**Rezoning from "Residential (Group C) 2" ("R(C)2") and "Open Space" ("O") zones to
"R(C)4" zone for a Proposed Residential Development
at Lot Nos. 519 RP (part) and 520 RP in D.D. 110 and adjoining Government land,
and
Rezoning from "R(C)2" to "O" zone
at Lot Nos. 121, 137, 138, 139 S.A and 139 RP (part) in D.D. 110
and adjoining Government land, Shek Kong, Yuen Long, N.T.
(S12A Amendment of Plan Application No. Y/YL-KTN/6)
- Further Information No. 4 -**

Proposed Rezoning of the Application Site from (i) “Residential (Group C) 2” and “Open Space “ Zones to “Residential (Group C) 4” Zone for a Proposed Residential Development at Lot Nos. 519 RP (part) and 520 RP in D.D. 110 and adjoining Government land and (ii) from “Residential (Group C) 2” to “Open Space” Zones at Lot Nos. 121, 137, 138, 139 S.A and 139 RP (part) in D.D. 110 and adjoining Government land at Shek Kong, Yuen Long, N.T. (S12A Amendment of Plan Application No. Y/YL-KTN/6)

Comments Forwarded from Fanling, Sheung Shui and Yuen Long East District Planning Office (FSS&YLE DPO)

Location of the concerned *Ficus macrocarpa* (細葉榕) (T112)

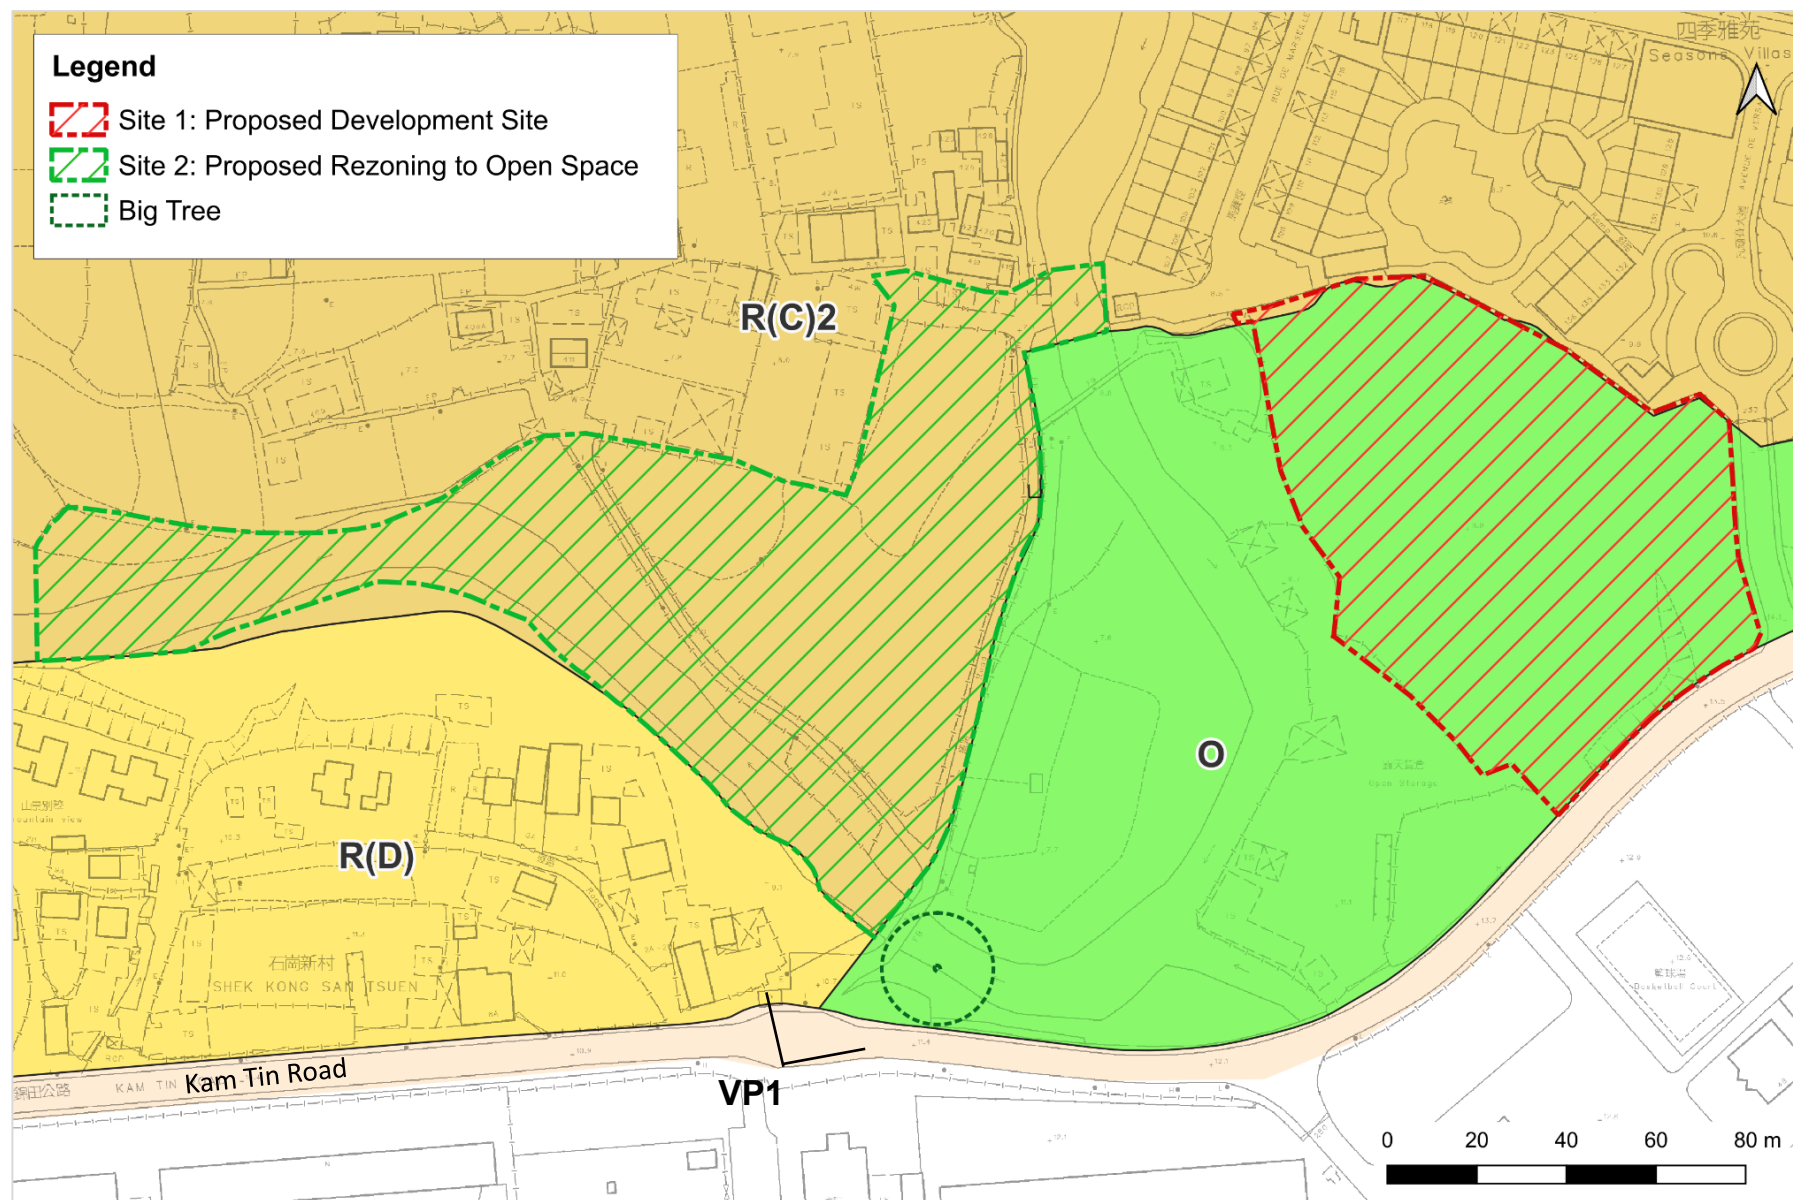
Comments	Responses
Comments from Planning Department (received on 23 April 2026) Contact person: Ms Andrea YAN; Tel. No.: 3168 4049	
I refer to your submission dated 2.4.2026. It is noted that the site is involved in a withdrawn application No. Y/YL-KTN/4 submitted by the same applicants, and Site 2 under the current application was part of the proposed residential development under the withdrawn application. Please elaborate why the current scheme is pursued. Thank you.	The withdrawn S12A Application No. Y/YL-KTN/4 was submitted by the same Applicants, with the subject site involving the current Site 1 and Site 2 as well as the other adjoining land. The total site area was about 3.27 ha, half of which was zoned “O” and proposed to be rezoned to “R(C)4”. Without alternative proposal to compensate for the loss of “O” zoned land, it was considered hardly justified to gain the public support and hence the TPB approval. Besides, the site configuration presented faces more technical challenges, if not impossible, in which the location and position of the vehicular access for connecting Kam Tin Road would be constrained by the existing rural settlements to the west and the big mature tree to the east, in result of taking up more Government land and the land zoned “O”. The concerned big tree is <i>Ficus macrocarpa</i> (細葉榕) with DBH of 1.591m, height of 20m and spread of 25m^[1] (see tree location and tree photo below). It also involved the existing local footpath frequently used by the nearby residents, drawing high concerns from them on the impact to the day-to-day access, even with reprovisioning (detour) proposal. The current scheme under this S12A Application is considered to present more merits as compared to the withdrawn Y/YL-KTN/4 Scheme due to the following reasons: 1. Reduced Development Scale – The current scheme for proposed residential development at Site 1 only is aimed to yield a total domestic GFA of 8,580m² only with a flat number of about 240, about one third of that under the withdrawn one (with a total domestic GFA of not more than 30,174m² with a flat number of about 916). This would be deemed more acceptable taking into account traffic demand and the local communities’ sentiment. 2. Increase in Land Area zoned “O” – The withdrawn Y/YL-KTN/4 Scheme aimed to convert the whole subject site to “R(C)4” zone, resulting in a total loss of about 17,600m²

Comments	Responses
	of land area zoned “O”. In contrast, the Current Scheme will result in a net increase in “O” zoned land of about 3,807m². 3. Longer Street Frontage for Access – Under the withdrawn Y/YL-KTN/4 Scheme, there was technical challenge and constraint for the location and position of the vehicular access for connecting Kam Tin Road. In contrast, the subject site under the Current Scheme has longer and direct frontage along Kam Tin Road (about 57m). 4. Limited Impact to Existing Use / Nearby Residents – Under the withdrawn Y/YL-KTN/4 Scheme, the existing local footpath frequently used by the nearby residents would be affected. Under the current scheme, Site 2 is zoned “Open Space” and the local context including the existing footpath and light poles will be unaffected should there be no particular implementation program of the open space by the Government. 5. No Decking Over Existing Watercourse Needed – Under the withdrawn Y/YL-KTN/4 Scheme, it requires decking over the existing watercourse for residential development. Under the current scheme, the existing topography and the existing watercourse in Site 2 will not be affected for residential development. More importantly, the proposed aggregated site area (for Sites 1 & 2) is primarily owned by the Applicants. The synergizing proposal represents a win-win situation in which there will not only been an increase in “Open Space” zoned land area, but also ensuring the implementation certainty of the planned residential development in Site 1. Note: [1] Based on Tree Survey conducted on 15th and 16th Jan, 4th Apr and 26th Jun 2022; and 19th Mar 2024; for the withdrawn S12 Application No. Y/YL-KTN/4.
